**Amendments to the Drawings:**

Replacement Sheet  
 Hiroyuki FUMIOKA  
 10/070,916  
 SOCKET FOR DIALYZER

Fig. 3

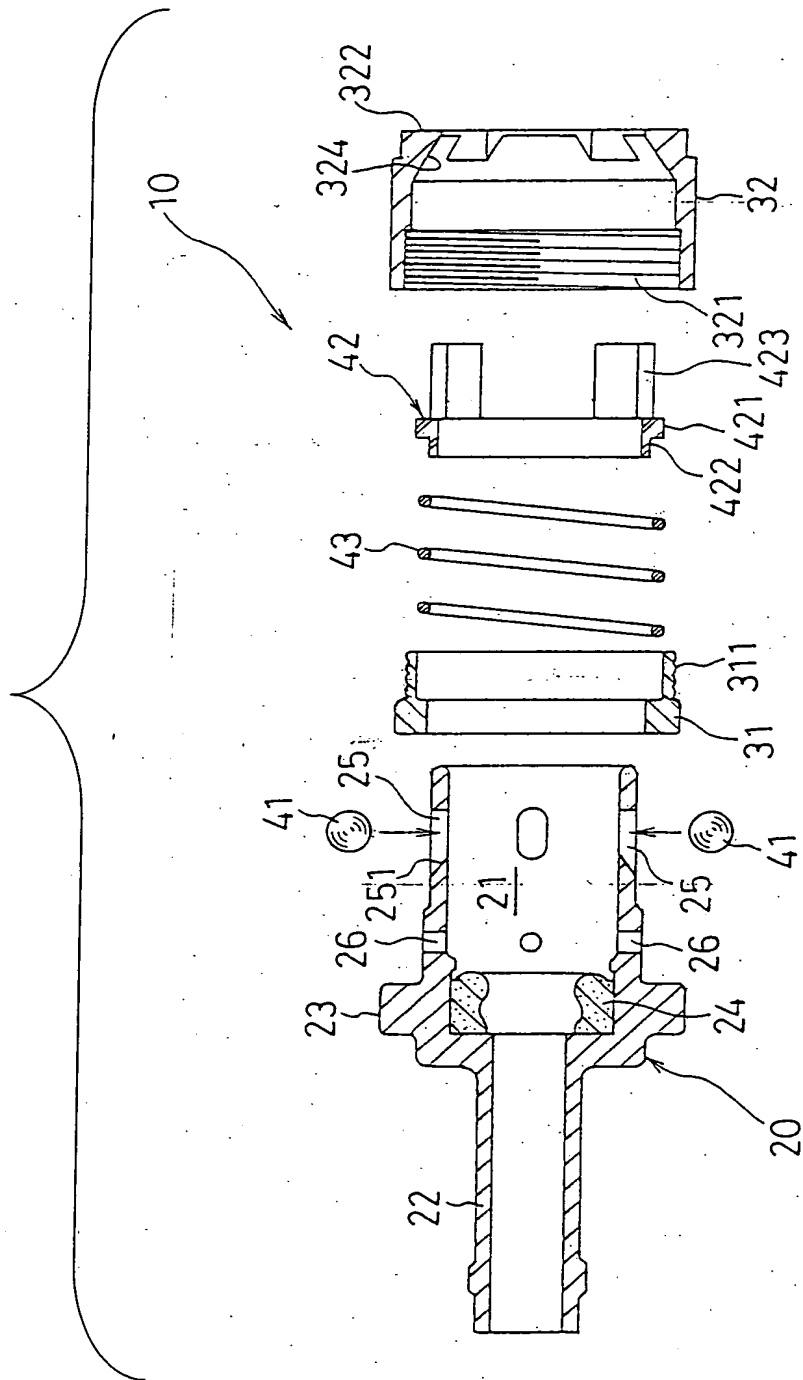
The drawing sheet attached in connection with the above-identified application containing Figure(s) 2-3 and 9-11 are being present as a new formal drawing sheet or sheets to be submitted for the previously submitted drawing sheet or sheets. The drawing Figures 2-3 and 10 have been amended to add a bracket embracing the illustrations. The drawing Figures 9-11 have been amended to add the legend Prior Art.
